SITE SUPPLEMENTAL INSTRUCTION

PROJECT: Forestside Estates
Attmar & Palleschi Drive
Brampton, ON

SITE SI NO. M-2

PURPOSE: To revise mechanical layout to suit architectural SI A-01 and City comments.

DRAWN MC	CHECKED LM	SCALE 1:50
DATE MAY, 2019	PROJECT 18-017	DRAWING M-45 OF -

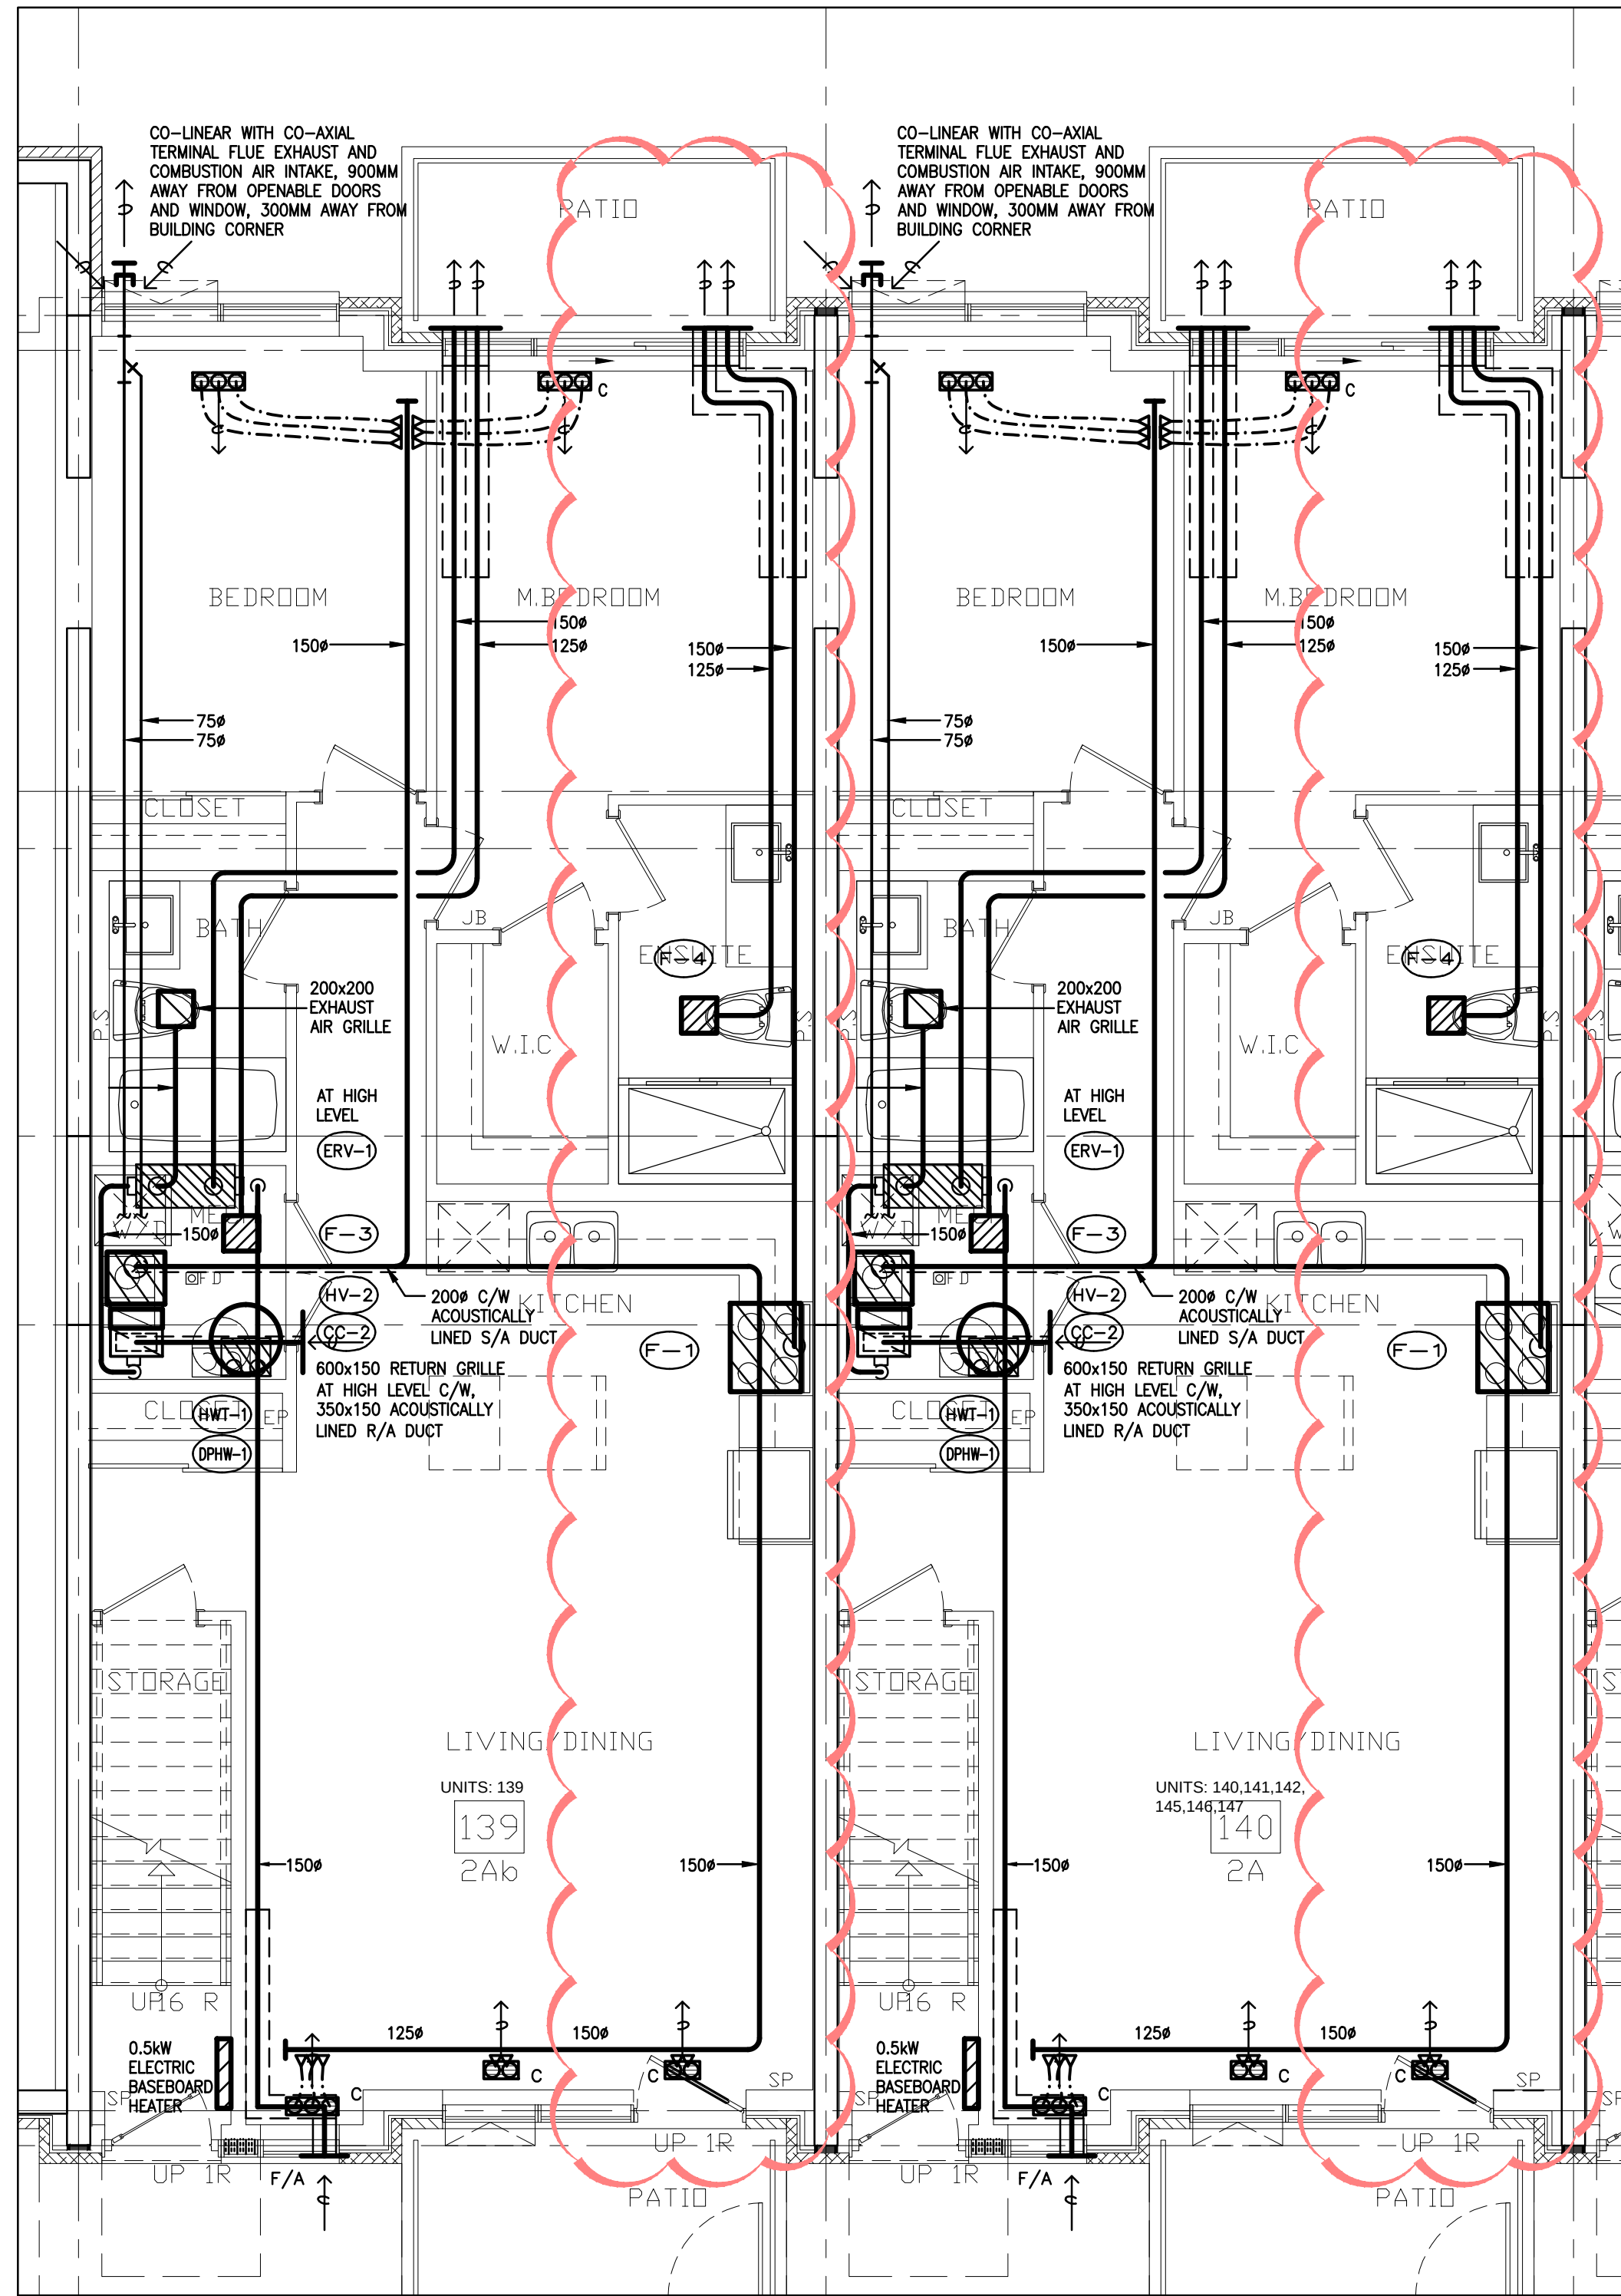
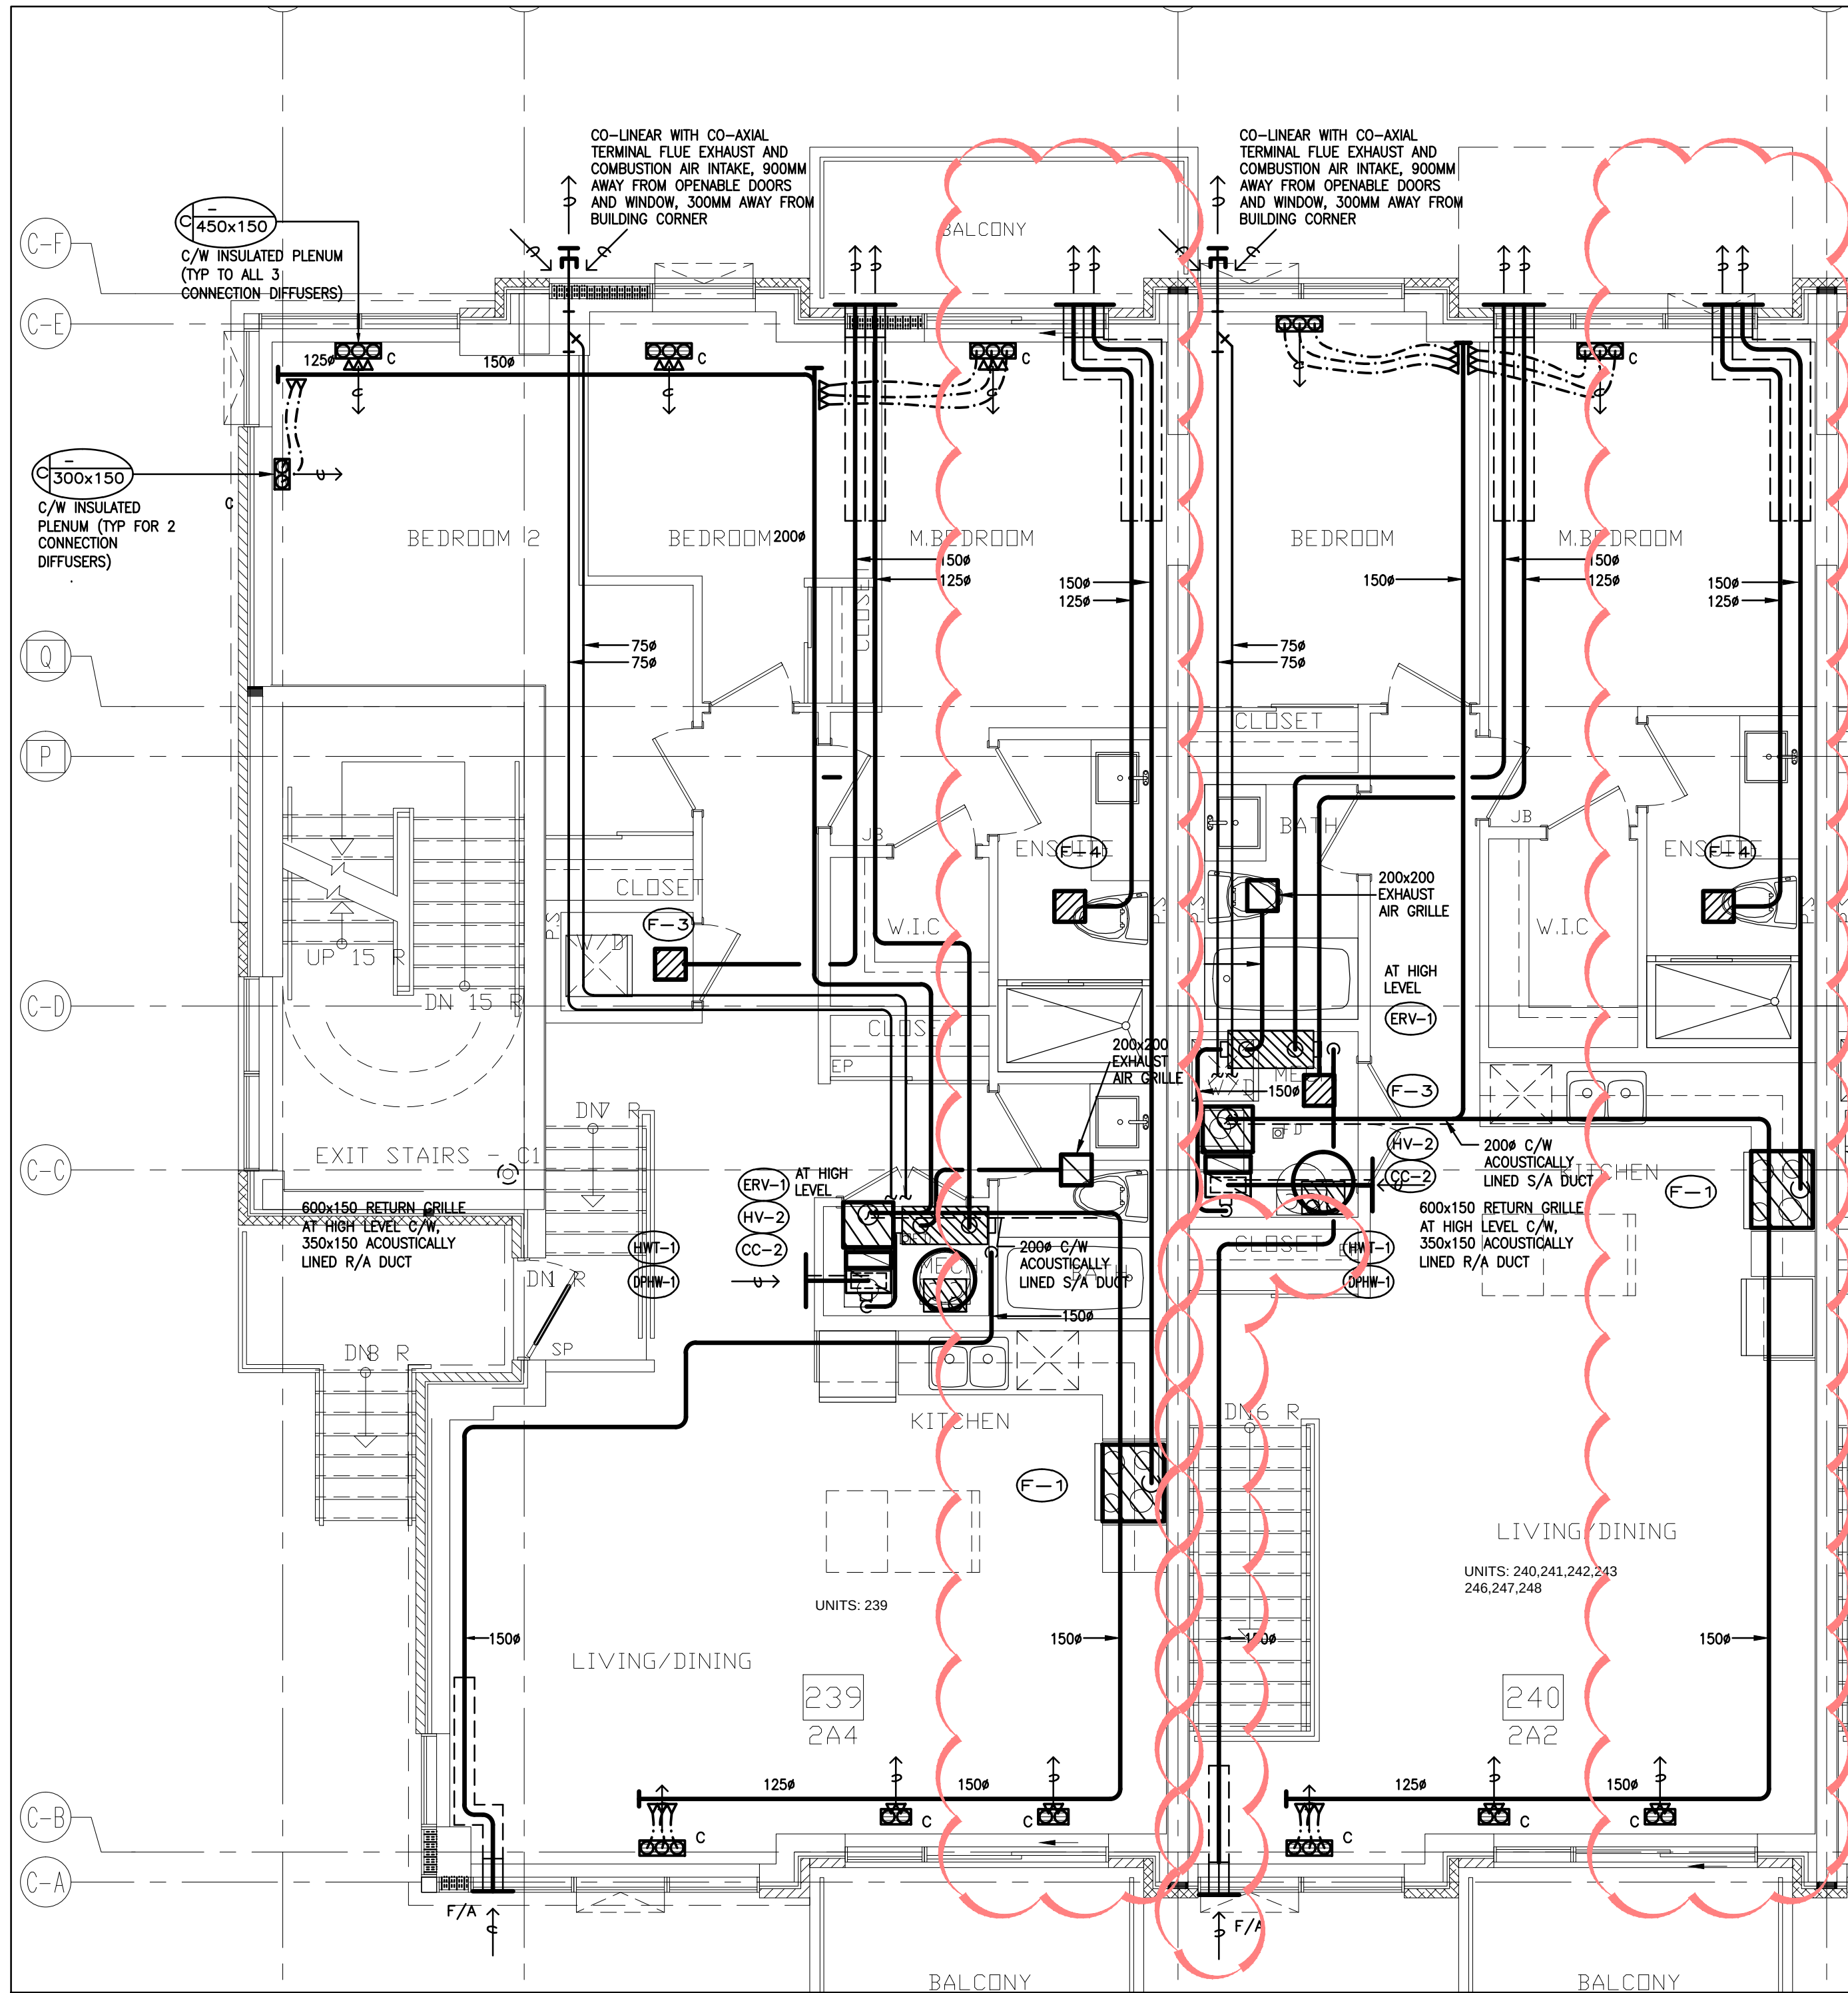
7.0 Reference Drawing M-45,M-46,M-47 (Typical Units - Mechanical) Issued

7.1 Added: Typical suite layout 2A1-R,2A-R and 2Aa-R.

7.2 Revised: Typical suite 2A,2A1,2Aa ,2Ab, 2A4,2A2,2A3,2A2a kitchen exhaust location according to code requirements.
